工程指示 / 要求簡箋(E.I.)

工程指示編號：EI / 2445 / 20

工程名稱：亞皆老街中電

工程項目：平台制房百葉地盤用防水片 (LV SWITCH ROOM 1) LG2

名稱	防水片拆圖	制圖	LHR	2020.06.12	修改		
材料	1.5mm 鋁板	復核	-	-	日期		
顏色	MILK	批准			圖號	J852-LVA-AP1-04

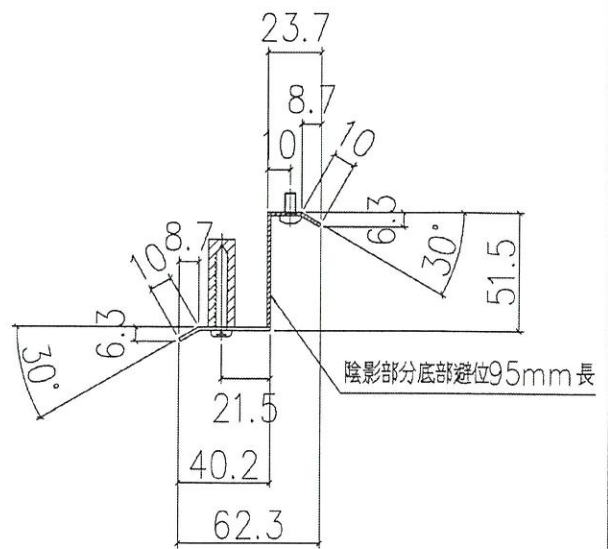
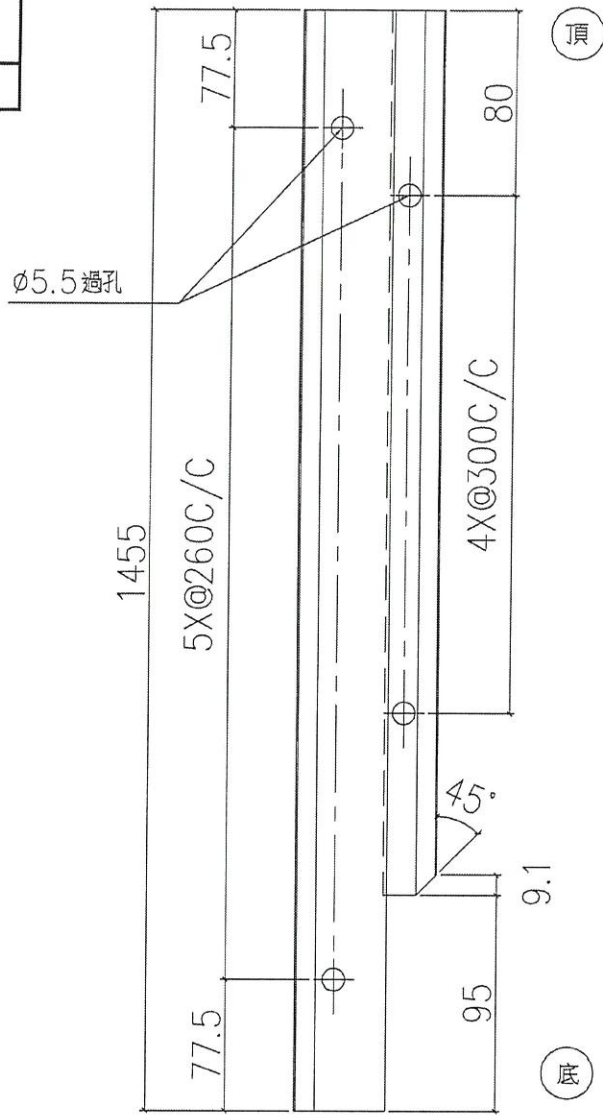
請按此加工制房百葉地盤用防水片

本工程所有防水片用鉻化片
